**SUBJECT: Followup response to 871013 ltr re shifts in limiting size small-break LOCA due to safety injection cross tie closure.**

Donald C. Cook Nuclear Plant Units 1 and 2  
Docket Nos. 50-315 and 50-316  
License Nos. DPR-58 and DPR-74  
SAFETY INJECTION CROSS-TIE: RESPONSE TO NRC QUESTIONS  
ON SMALL-BREAK LOCA ANALYSES FOR UNIT 2

LIMITING SMALL BREAK LOCA CONSIDERATIONS  
FOR OPERATION OF DONALD C. COOK UNIT 2 WITH CLOSURE  
OF THE HIGH HEAD SAFETY INJECTION CROSS-TIE

FIGURE 1

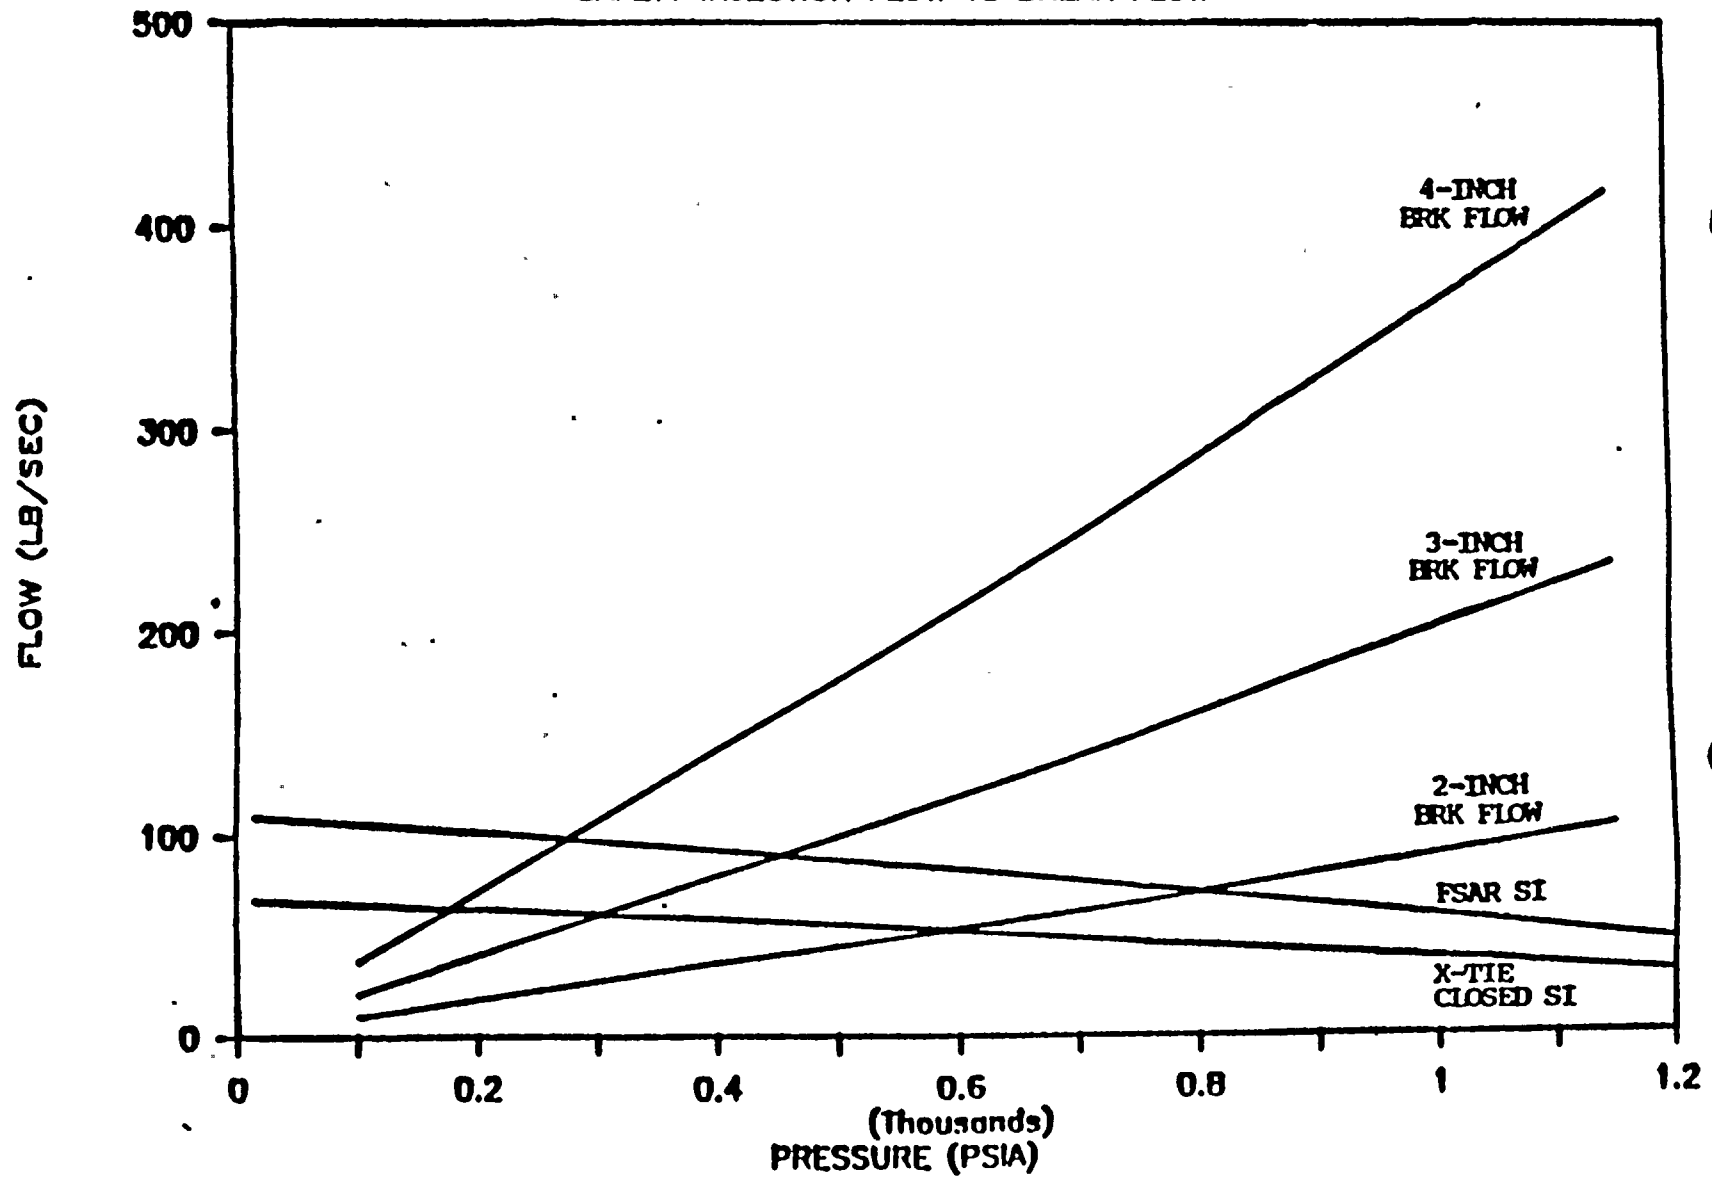
previously, in the event of a small break LOCA, the RCS pressure tends to reach equilibrium where pumped safety injection flow equals the break flow. Figure 1 shows a conservative estimate of the RCS pressure equilibration point for Donald C. Cook Unit 2 in the event of a 4-inch, 3-inch and 2-inch diameter break for both the current licensing basis safety injection flow and the safety injection flow available when the HHSI cross-tie is closed. The break flow rates are conservatively estimated for saturated steam. The 2-inch diameter break is expected to equilibrate at or above the Donald C. Cook Unit 2 minimum accumulator setpoint pressure of 600 psia when the HHSI cross-tie is closed. Therefore, recovery from RCS inventory depletion transient for the 2-inch diameter break should be dependent upon safety injection flow delivery alone.

To determine if the safety injection flow available with the cross-tie closed is capable of mitigating the consequences of a 2-inch break at Donald C. Cook Unit 2, a system mass inventory calculation was performed. The calculation assumed that the depressurization transient and the break flow rates calculated for the 2-inch break in a typical Westinghouse 4-loop plant represented in WCAP-11145 (reference 6) would be representative of the response in Donald C. Cook Unit 2 and could be used as boundary conditions. The Donald C. Cook Unit 2 safety injection flow rates available with the HHSI cross-tie closed were applied to the rate of depressurization as shown in WCAP-11145 to determine the safety injection flow available throughout the transient. The safety injection flow in conjunction with the break flow could then be combined to determine the RCS mass inventory depletion vs. time resulting from a two-inch diameter break with the reduced safety injection flows. The transient mass inventory was then used to determine the vessel mixture level during the 2-inch LOCA event to predict the depth and duration of core uncover.

The core uncover transient predicted to result in the event of a 2-inch diameter LOCA with the reduced safety injection resulting from closure of the cross-tie line indicates that a relatively long shallow core uncover will result. The maximum depth of core exposure is not expected to exceed 1.7 ft. The total duration of uncover was estimated to be 1575 seconds with the deepest uncover occurring between 4250 and 4500 seconds following break initiation. Based on a comparison of various uncover transient core steam flow rates, core decay heat levels and clad heat up rates, an estimate of the 2-inch PCT temperature range was made for the uncover transient predicted for the 2-inch break with the reduced safety injection flow. Assuming the licensed core power level of 3411 MWth, a total core peaking factor of 2.32 and Westinghouse standard 17x17 fuel assemblies, the 2-inch break with the reduced safety injection flows is expected to result in a peak clad temperature between 1060°F and 1200°F. As a result, the 2-inch diameter break PCT is expected to remain less limiting than the 3-inch and 4-inch break PCTs determined for Cook Unit 2 with the reduced safety injection flow.
